GR-1 Project Objectives

RESPONSES TO COMMENTS

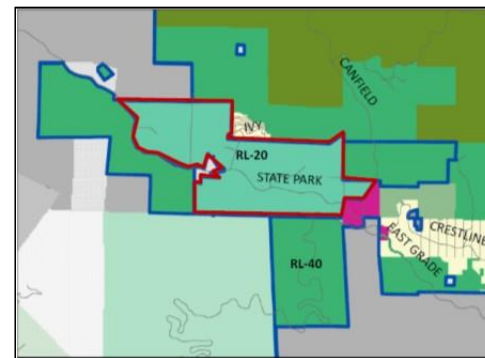
L-11	Alpine: The area of 1:10 south of Abrams Ridge should change to 1:20.	<p>The comment does not raise an issue concerning the sufficiency of the analysis in the Draft SEIR. The comment will be included in the administrative record that will be considered by the decision-makers in evaluating the Project. Ultimately, the Board of Supervisors will determine the final land use designations for the Project. It appears that this comment is referring to 17 parcels (outlined in red on Figure L-11, which is an excerpt from Draft SEIR Figure 1-2A) located along Japatul Road south of the Rancho Palos Verde area in the</p>  <p style="text-align: center;">Figure L-11</p>

Figure L-66

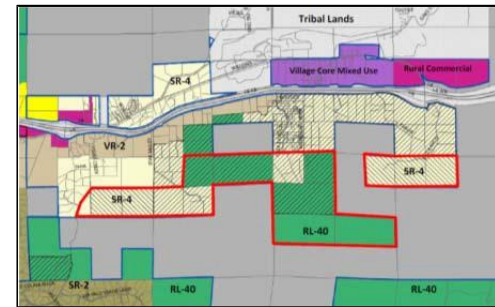
L-67	While not as environmentally beneficial as the Modified Project, the Modified Alpine Alternative is nevertheless a pragmatic option that would allow the County to pursue	The comment does not raise an issue concerning the sufficiency of the analysis in the Draft SEIR. The comment will be included in the administrative record that will be considered by the decision-makers in

planned future studies along a far more responsible – and CEQA-compliant – course than the original Alpine Alternative.	evaluating the Project. Ultimately, the Board of Supervisors will determine the final land use designations for the Project. The comment characterizes its proposed alternative as a “pragmatic approach”; however, CEQA requires project alternatives to lessen the severity of identified impacts while also meeting the majority of project objectives.
L-68	<p>Conclusion</p> <p>The above discussion demonstrates that the Modified Alternative not only substantially lessens virtually all the significant impacts of the Project and it better satisfies the overwhelming majority of Project objectives. It is well settled that “[i]f there are feasible alternatives or feasible mitigation measures that would accomplish <i>most</i> of the objectives of a project and substantially lessen the significant environmental effects of a project subject to CEQA, <i>the project may not be approved without incorporating those measures.</i>” (<i>Center for Biological Diversity, Inc. v. FPL Group, Inc.</i> (2008) 166 Cal.App.4th 1349, 1371 fn 19, emphasis added, [citation to Pub. Resources Code §§ 21000(g), 21002, Guidelines § 15091].) For this reason, CEQA requires adoption of the Modified alternative or something very closely resembling it.</p>	See Responses to Comments L-1 through L-67. The comment will be included in the administrative record that will be considered by the decision-makers in evaluating the Project. Ultimately, the Board of Supervisors will determine whether to approve the Proposed Project or an alternative to the Project.
